STAFF RECOMMENDATION
1306 Beechwood Avenue
October 21, 2015

Application: New construction - addition
District: Belmont-Hillsboro Neighborhood Conservation Zoning Overlay
Council District: 18
Map and Parcel Number: 10513013100
Applicant: Sandi Adams, Designer
Project Lead: Sean Alexander, sean.alexander@nashville.gov

<p>Description of Project: To construct a two-story addition to a one and one-half story house. The addition will be three feet, six inches (3'-6") taller than the historic house, but the side walls will be stepped in two feet (2') from the sides.</p> <p>Recommendation Summary: Staff recommends approval of the proposed addition to 1306 Beechwood Avenue with the condition that the windows and doors are approved prior to purchase, finding the addition to meet the design guidelines for the Belmont-Hillsboro Neighborhood Conservation Zoning Overlay.</p>	<p>Attachments A: Photographs B: Site Plan D: Elevations</p>
-----------------------------------------------------------------------------------------------------------------------------------------------------------------------------------------------------------------------------------------------------------------------

PROPOSED ROOF PLAN

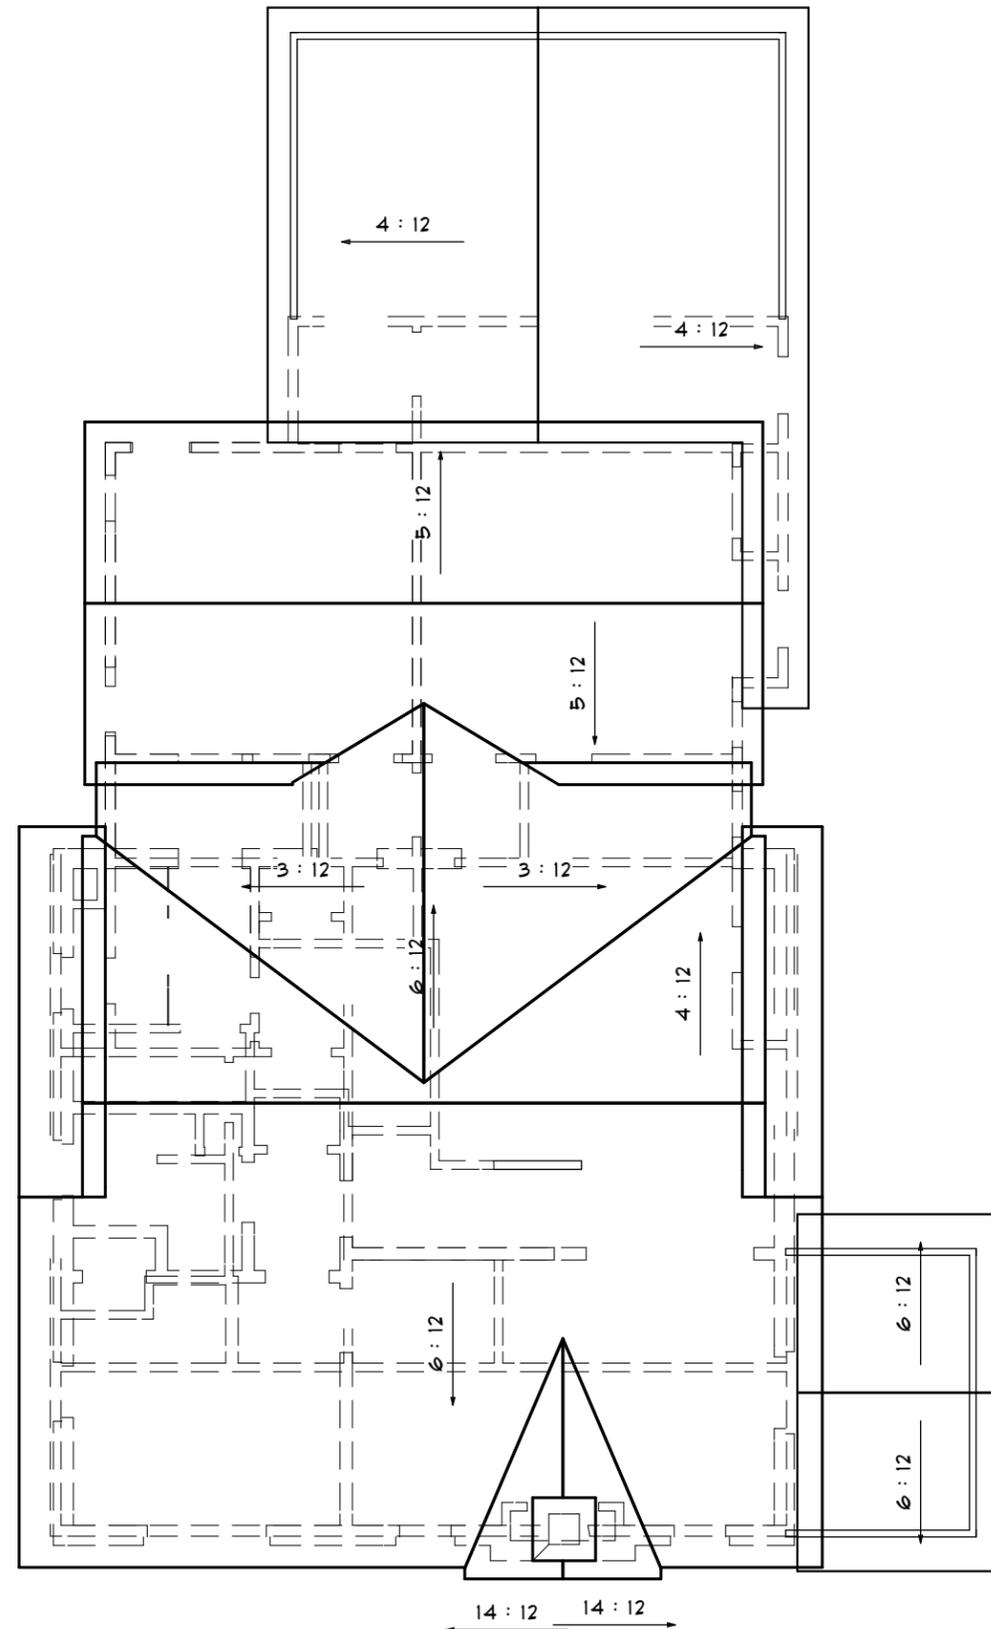
The addition will extend the front slope of the roof up and to the rear creating a new ridge two feet (2') higher than the existing roof. The raised roof portion will be stepped two feet (2') in from the sides of the existing roof, retaining the eaves as an indication of the original side-gabled form. From the new higher ridge and extending back to the rear will be a one and one-half story addition. On the first story, both side walls of the addition will step in from the sides of the house by two feet (2').

From the new roof ridge, raised two feet (2') from the existing ridge, the addition will extend back twenty feet (20') and then rise an additional eighteen inches (18"). Altogether the addition will be three feet, six inches (3'-6") taller than the original

building. Because the addition is stepped in two feet (2') from the sides of house and the height increases over forty feet (40') back from the front of the building, Staff finds that its impact and visibility will be minimal. Staff finds the proposed addition will meet section II.B.1.e of the design guidelines.

PROPOSED LEFT SIDE ELEVATION

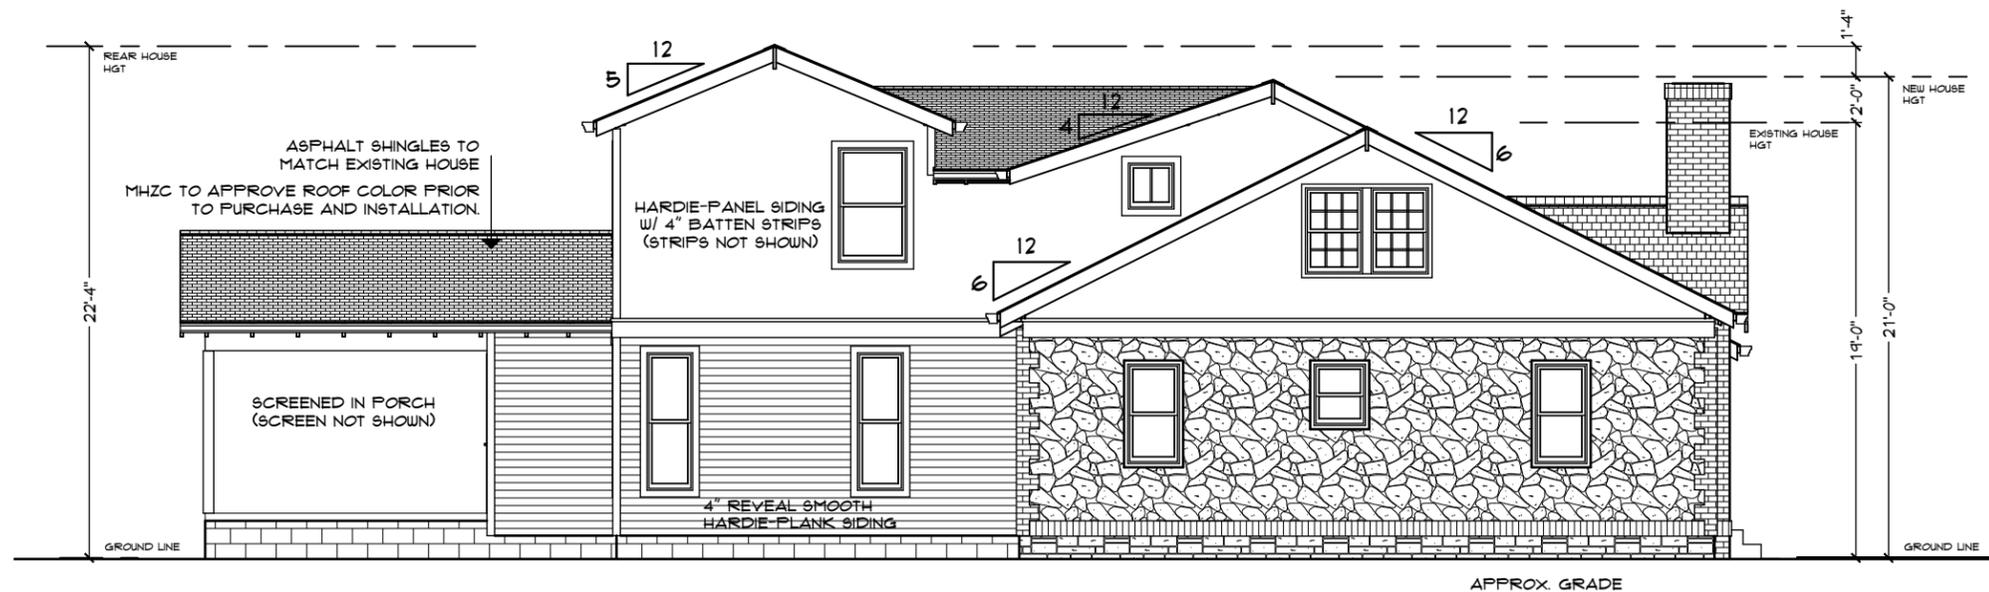
The addition will step in from the sides of the house by two feet (2') on both sides, helping to distinguish the new construction from the historic house. After extending back seven feet, six inches (7'-6") the addition will step back in line with the side of the original house on the right side, but the upperstory gable wall will remain set two feet (2'). The addition does not step back out on the left side.
